From: Steve Woods - Global RSO <Steve.Woods@Halliburton.com>
To: "jbj2@nrc.gov" <jbj2@nrc.gov>
Date: 3/31/03 12:44PM
Subject: FW: Densometer restraint option

Device modification

Densometer Restraint System

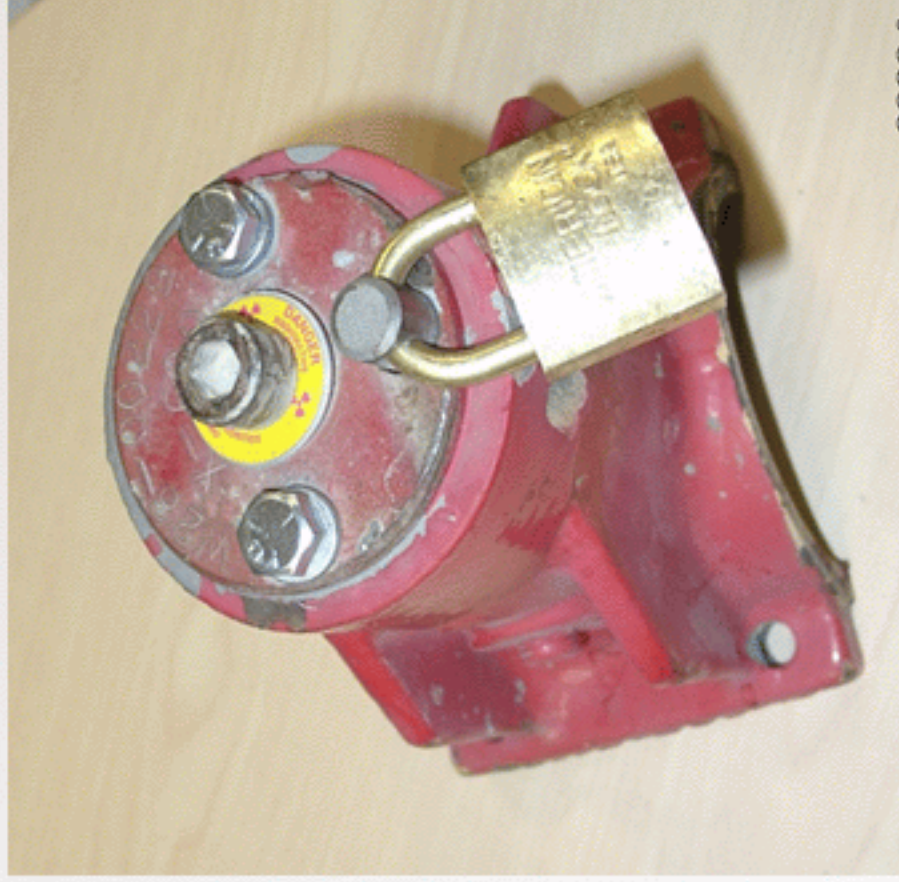
- Enhanced source security
- Single restraint required per densometer
- Independent of end-connection restraints
- Secures body half to prevent theft.
- Two sizes cover all densometer configurations
- Installs without densometer removal
